# Technical Service Bulletin

**SUBJECT:**  
Drive Line Vibration  
At Speeds Over 60 MPH

**NO:** 03-01-98  
**GROUP:** Differential/DriveLine  
**DATE:** Mar. 27, 1998

1997 - 1998 (XJ) Cherokee

**Figure 1**

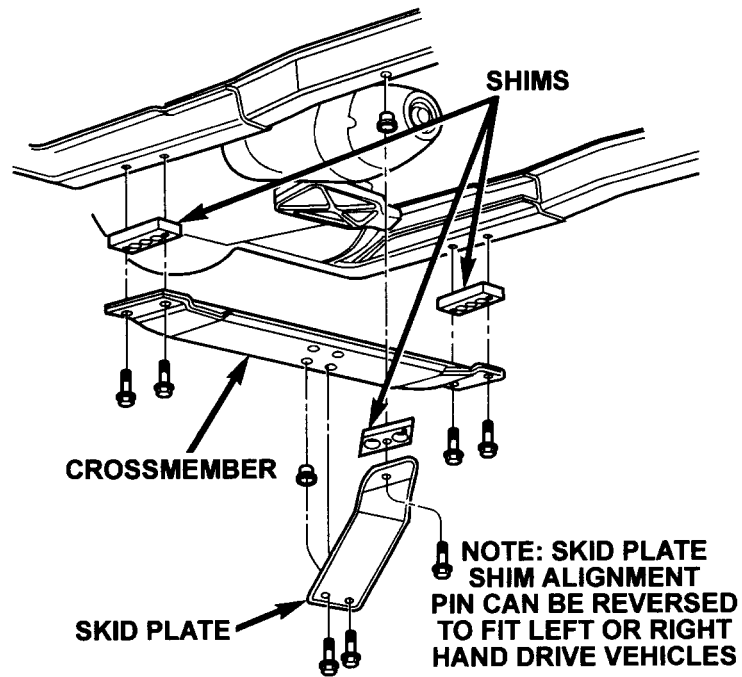
1. Raise the vehicle and support the transmission with an adjustable jack stand to allow for removal of the transmission cross member.
2. Loosen but do not remove the engine support bracket to frame sill attaching nuts.
3. Loosen but do not remove the exhaust pipe nuts at the exhaust manifold to allow for movement during the shim installation.
4. Remove the transfer case skid plate to frame rail bolt if equipped.
5. Remove the transmission cross member to frame rail bolts.
6. Lower the cross member and install the cross member with the new shims, p/n 05011910AA, and longer bolts, p/n 06101505, and hand tighten the bolts. (See figure 1)

7. Install the skid plate shim, if equipped, and hand tighten the bolts.

8. Tighten the cross member and skid plate bolts to 41 Nm (30 ft. lbs.).

**Figure 2**

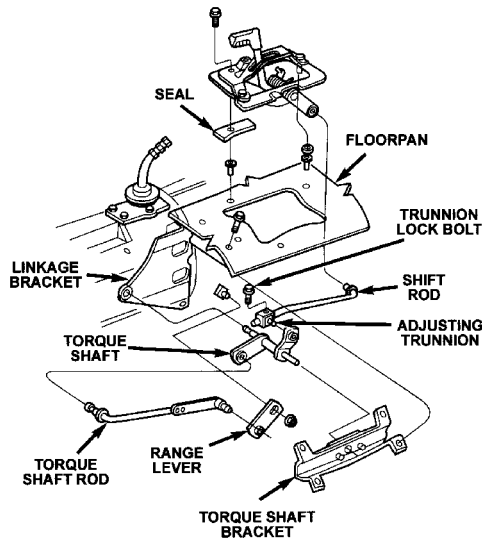
11. Remove the transfer case linkage bracket. (See Figure 2)
12. Install the new bracket, p/n 05011845, and tighten the bolts to 30 Nm (22 ft. Lbs.).
13. Check the transfer case shifter operation and adjust the linkage as necessary.
14. Remove the rear propeller shaft.
15. Install the new prop shaft containing the damper. Replace the universal joint straps and nuts with p/n J4006926 & J3240553. Tighten the nuts to 19 Nm (14 ft. lbs).
